Steven H. Emerman, Ph.D.
Specializing in Groundwater and Mining

January 20, 2021

Are the stormwater plans for the proposed Central Park development consistent with the 2013 City of Charleston Stormwater Design Standards Manual?

Figure 1. Comparison of AECOM stormwater improvements with SCDOT/USGS watershed (amethyst line)

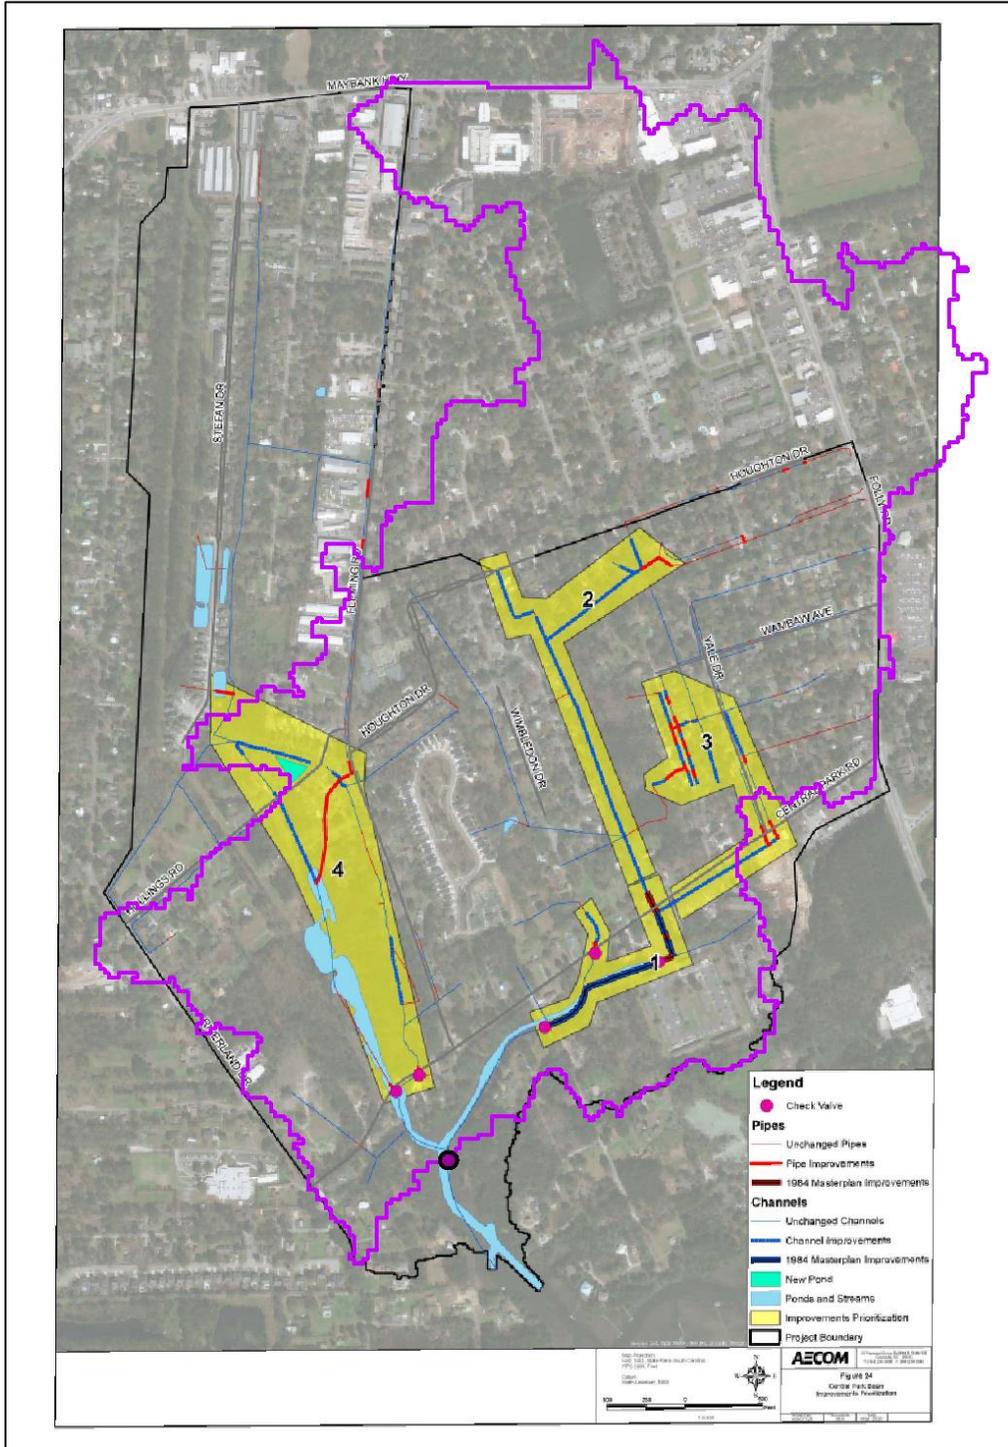
The watershed boundary assumed by the AECOM study is very different from the watershed boundary that could be created using the StreamStats tool. As a consequence, some of the

stormwater improvements recommended by the AECOM study are not even in the Central Park watershed. Figure 1 at the end of this memo shows the watershed boundary from the USGS/SCDOT StreamStats model (amethyst line) superimposed on the stormwater infrastructure improvements that were recommended by the AECOM study. To the west of the watershed boundary are three proposed pipe improvements and part of a channel improvement that are outside of the watershed. To the southeast of the watershed boundary are two proposed pipe improvements and part of a channel improvement that are outside of the Central Park watershed. These particular stormwater improvements cannot possibly have any effect on stormwater drainage in the Central Park watershed.

In summary, I would not assume that implementation of the stormwater improvements that were recommended by the AECOM study would mitigate flooding due to the Central Park development.
